ID0000027
US Silver Idaho, Inc.
Coeur and Galena Mines and Mills
Response to Comments

Environmental Protection Agency (EPA)
Region 10
June 2019

Prepared by:
Cindi Godsey, EPA

Figure 17. Location of gaining and losing subreaches and average gains and losses in dissolved cadmium loads for the South Fork Coeur d'Alene River near Osburn, Idaho, July 27–29, 1999. (Location of study reach shown in figure 1)

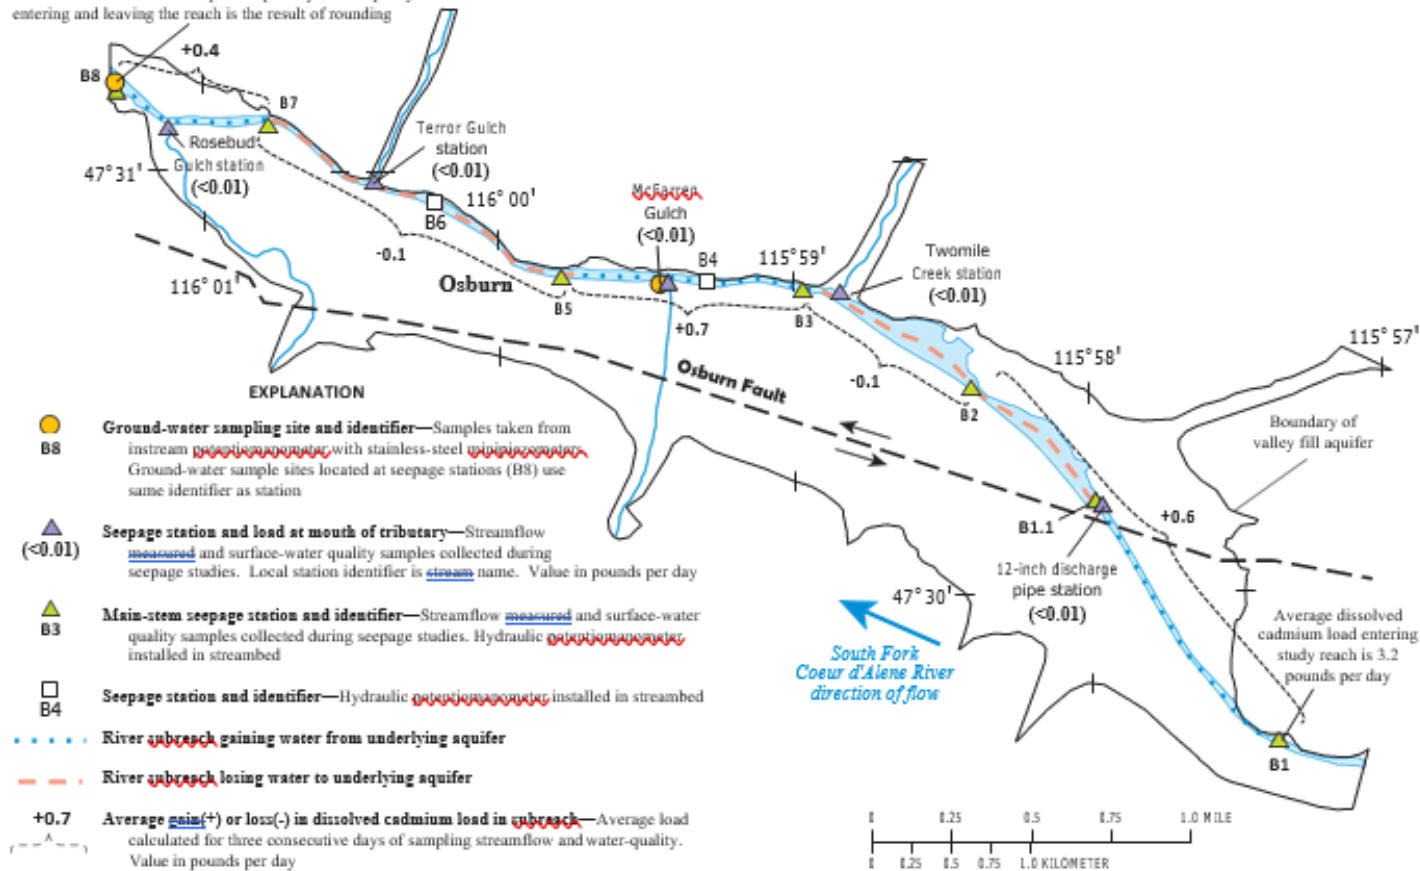
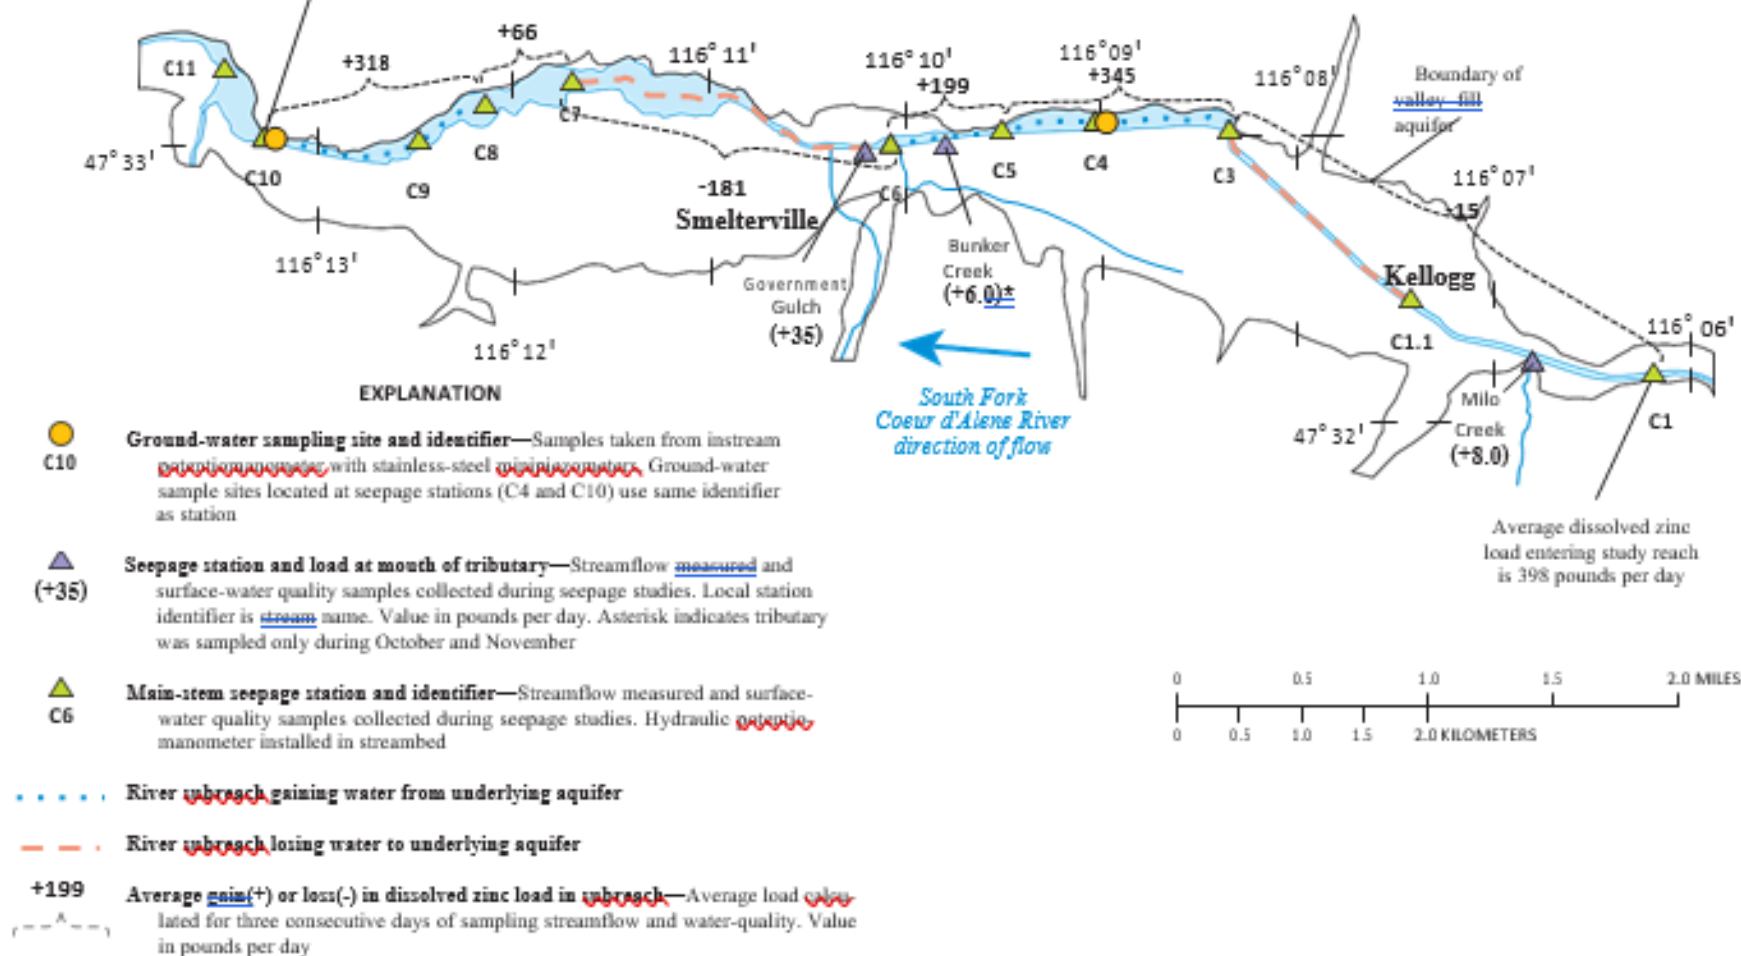
4. **Comment:** ICL requests that EPA reevaluate and adjust the critical low flows for the South Fork of the Coeur d'Alene River ("SFCdA") by incorporating water flow data from USGS' Elizabeth Park water monitoring station, USGS 12413210, and evaluating it through the EPA software tool BASINS.

We are concerned that EPA's proposed critical low flows for the SFCdA River inaccurately doubled from the current permit. The proposed critical low flows for U.S. Silver's discharge to the SFCdA are higher than the critical low flows recently used to calculate effluent limits for the Page and Smelterville Wastewater Treatment plants and the Central Treatment Plant (CTP), which discharge into the SFCdA approximately 12 and 8 river miles, respectively, downstream of U.S. Silver's Outfall 002.

According to EPA's proposed critical low flows for U.S. Silver, the SFCdA River has higher flow volumes upstream than it does downstream. This cannot be true and EPA should re-propose critical low flows that accurately reflect water conditions in the SFCdA River to ensure the effluent limits derived from these flows are protective of the designated uses of the river.

Response: EPA used flow data that was collected by US Silver for the receiving waters at the point of the discharge. It should be noted that the SFCdA River is a complex system with gaining and losing reaches. EPA consulted the report: *Dissolved Cadmium, Zinc, and Lead Loads from Ground-Water Seepage into the South Fork Coeur d'Alene River System, Northern Idaho, 1999*. Water-Resources Investigations Report 01-4274, which was prepared by USGS in cooperation with EPA. Several losing and gaining reaches between Osburn and Smelterville are identified, see maps in Attachment A. Given this information, EPA made no changes to the final permit based on data from another flow set.
